December 14, 2007

Subject: SLIC Case RO0002475 and Geotracker Global ID T06019761004, JB Auto, 819 E. 12th Street, Oakland, CA 94606

Alameda County Environmental Health (ACEH) staff has reviewed the Spills, Leaks, Investigations, and Cleanups (SLIC) case file for the above-referenced site, including the recently submitted document entitled, "Revised Remedial Action Plan," dated November 16, 2007. The Revised Remedial Action Plan (RAP) proposes a scope of work that includes 10 direct push borings for pre-excavation sampling, remedial excavations, and future installation of three groundwater monitoring wells. The proposed scope of work is generally acceptable and may be implemented provided that the technical comment below is addressed and incorporated during the proposed field investigation. Submittal of a revised Work Plan is not required unless an alternate scope of work outside that described in the Revised Remedial Action Work Plan or technical comments below is proposed.

LEGEND ◆ BLYMYER ENGINEERS BORES ⊕ PREVIOUS BASICS ENVIRONMENTAL BORES BGS BELOW SURFACE GRADE MD METAL DETECTOR TC TERRAIN CONDUCTIVITY VMG VERTICAL MAGNETIC GRADIENT		SITE PLAN FORMER J & R AUTOMOBILE DISMANTLERS 819-823 12th ST. OAKLAND, CA	FIGURE 2
		BEI JOB NO. 202041	DATE 10-3-02

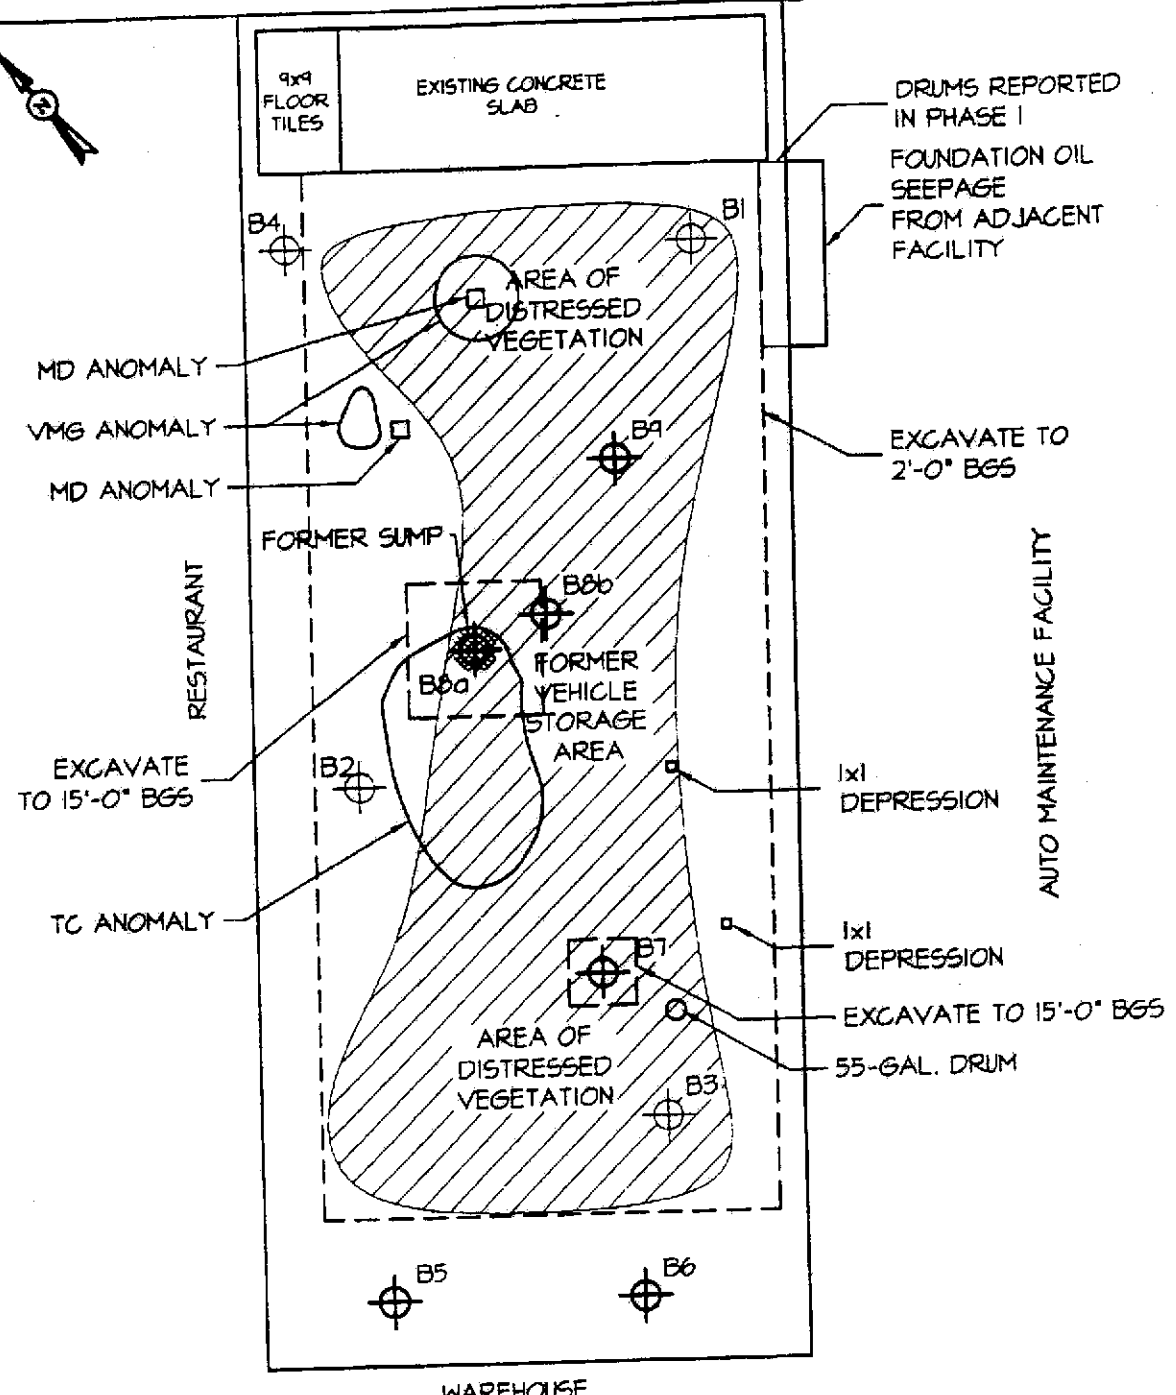
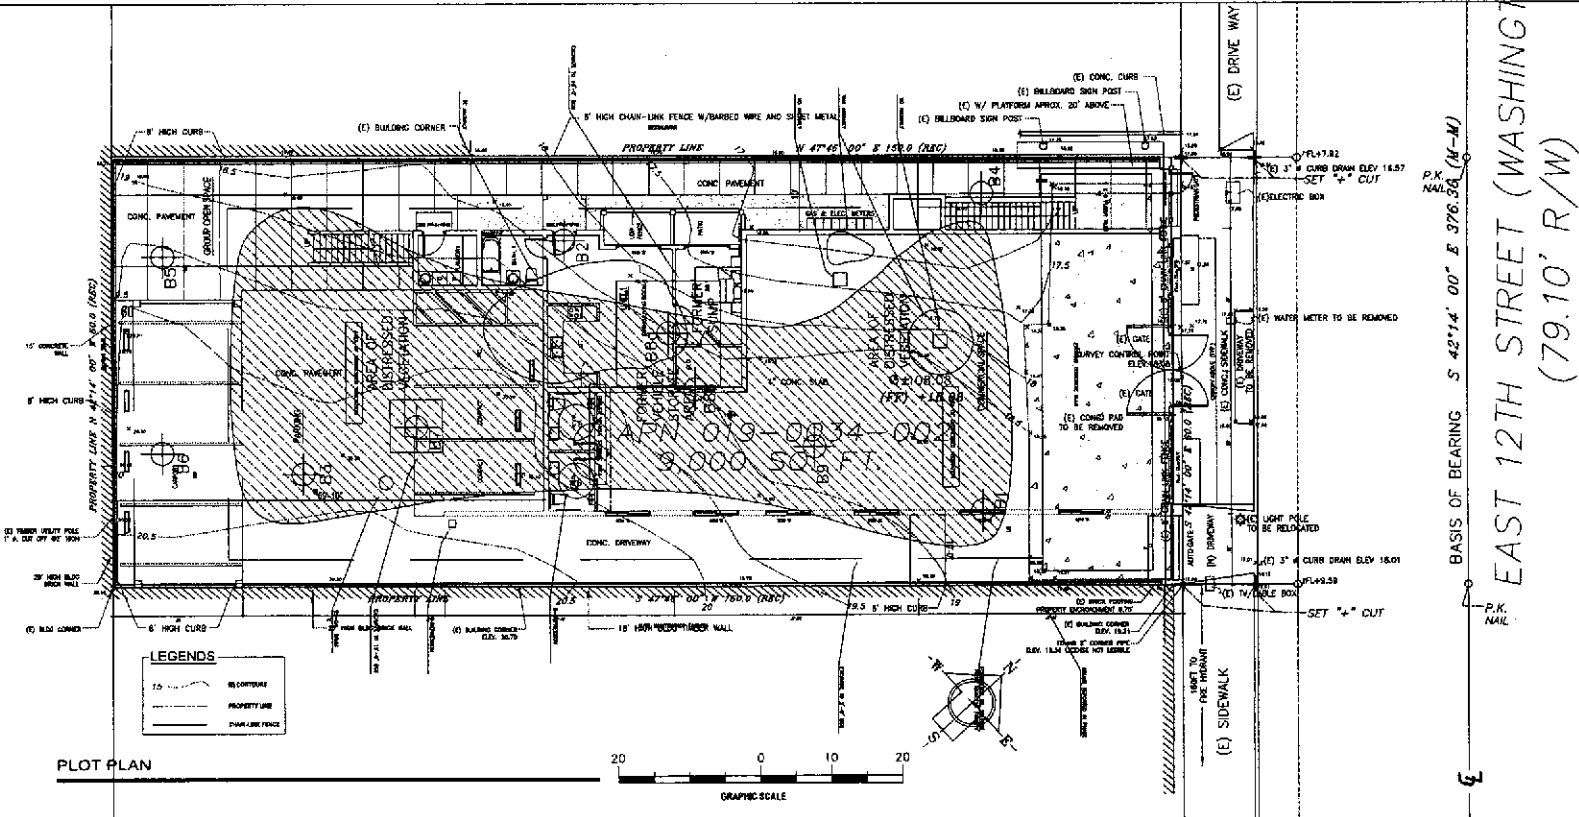
Attached for your review is a sketch of the site showing the location of previous soil borings where soil samples were collected for chemical analysis. Chemical data for those soil samples

were reported to your office by the previous owner. I have included the plot plan that includes approximate footprint of the concrete slab floor for a new building, driveway, parking, and pathway that I am planning to construct at the site. The proposed concrete slab floor for the building covers the majority of the site. The locations of the former sump and Borings B8a and B8a would be covered entirely by the proposed concrete slab floor.

Please advise if the proposed capping of the site with a concrete slab flooring would be acceptable to prevent further contamination of the site. I am looking forward to receiving your feedback.

Based on our review of your request and the case file, we do not concur with the proposal to cap the site. Shallow soils at the site are contaminated with elevated concentrations of petroleum hydrocarbons and metals over much of the site. Petroleum contamination extends to depths of 15 feet or greater within the area of a sump encountered in boring B8 near the center of the site. The lateral and vertical extent of the sump and contamination from the sump have not been defined nor have the soils and groundwater been analyzed for all potential contaminants. Benzene was detected in a grab groundwater sample collected from boring B-8 at a concentration of 1,700 micrograms per liter ($\mu\text{g/L}$). Volatile organic compounds in soil and/or groundwater beneath the proposed building pose a potential risk for indoor air vapor intrusion. In addition, off-site migration of groundwater containing elevated concentrations of VOCs in groundwater could pose potential human risks for off-site receptors. We conclude that the site may pose both short-term and long-term potential risks to human health and the environment and is not suitable for capping.
